# UNITED STATES PATENT AND TRADEMARK OFFICE

APPLICATION NO.	FILING DATE	FIRST NAMED INVENTOR	ATTORNEY DOCKET NO.	CONFIRMATION NO.
09/583,583	10/23/2000	Mathieu Vandenbossche	1200-370	2518

**Office Action Summary**

## **DETAILED ACTION**

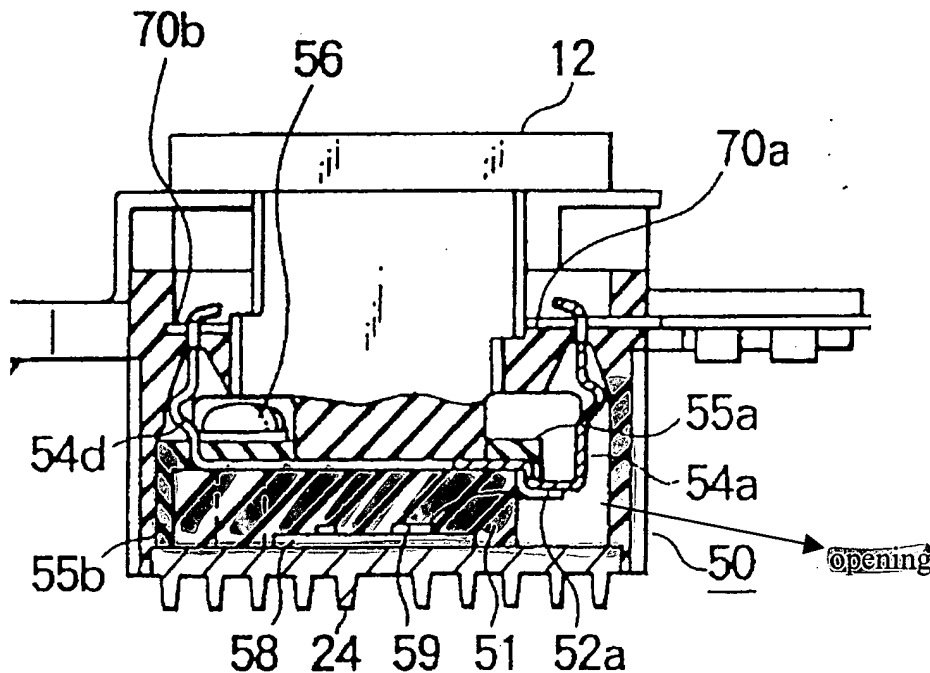
Referring to claim 1, Komurasaki et al. disclose a brush holder (12) for a vehicle alternator having a housing (2), the brush holder (12) comprising: an insulating support (51) having an opening (see figure below), heat dissipating means (24,58) having a metallic seat (58) fixed to the support (51); and an electrical circuit (59) comprising: a semiconductor control component, in which the seat (58) on the one hand receives for fixing on one of its faces the control component (51) by means of an opening in the support (see figure below) and on the other hand belongs to the heat dissipation means (24,58) in contact with an ambient environment and arranged so as to receive heat from the control component (59), wherein the seat (58) is separate from the housing (2) and not in contact with the housing (2), the seat (58) is mounted within a thickness of the support (51) and the seat (58) receives on the other of its faces a heat

dissipator (24) so that the heat dissipation means (24,28) is composed of two distinct and adjacent parts (Figure 1).

7. Applicants argument that the opening is for the passage of the screw is not persuasive. As shown in the figure above (Fig. 1 in Komurasaki) there is an opening where the control component is fixed to the seat.
